**TOWN OF BAY HARBOR ISLANDS
PLANNING AND ZONING BOARD**

February 7, 2017

FINAL AGENDA

A3.03 EAST ELEVATION
SCALE: 1/4"=1'-0"

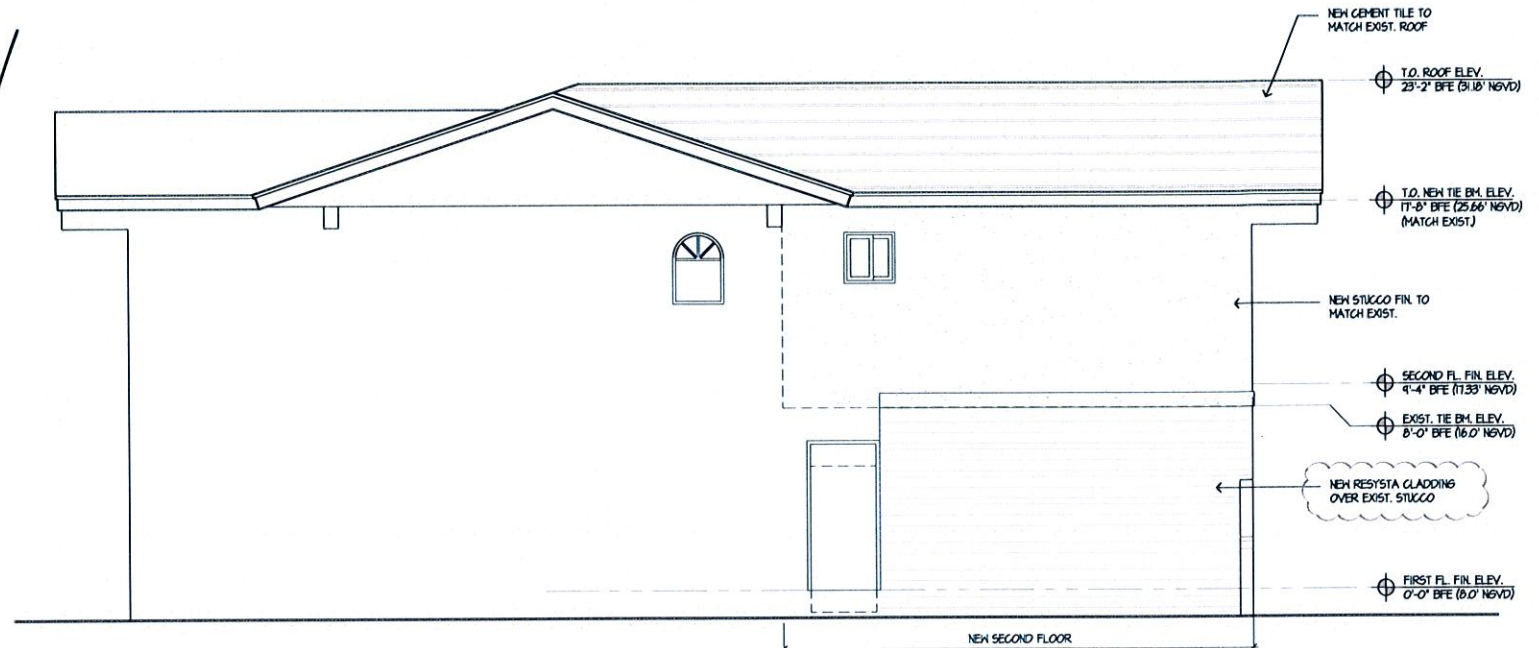
1. *Replace the existing arched windows on the east side of the front façade with square windows to match the proposed design of the addition.*

The revised elevations and renderings submitted by the applicant now show square windows replacing the arched windows. MMPA notes that the floor plans do not reflect the change, however, this can be corrected / revised when the construction documents are submitted.
